Limited Visual Dam Safety Inspection Summary Report

MA-141

Wailuku Project District Retention Basin

May 2006

141 inlet head cutting - Looking from inlet channel to basin

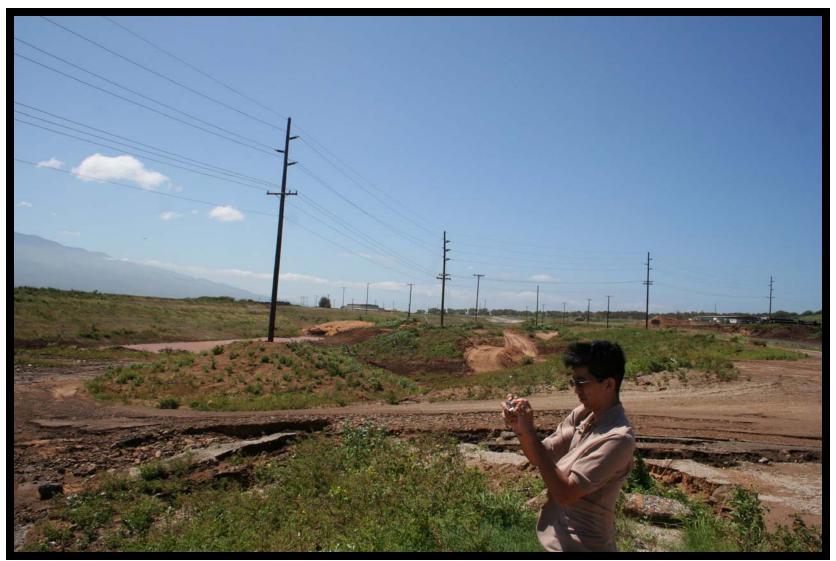
The inflow ditch and pipes are in fair condition. Headcutting is occurring where the ditch enters the basin. Owner intends to armor during construction. Inflows are not divertable and are driven by drainage area.

- a. The intake works appeared to be in fair to poor condition and requires corrective action.
- b. The intake works needs maintenance and/or repair. Description: Repair head cutting and armor area where ditch enters basin.
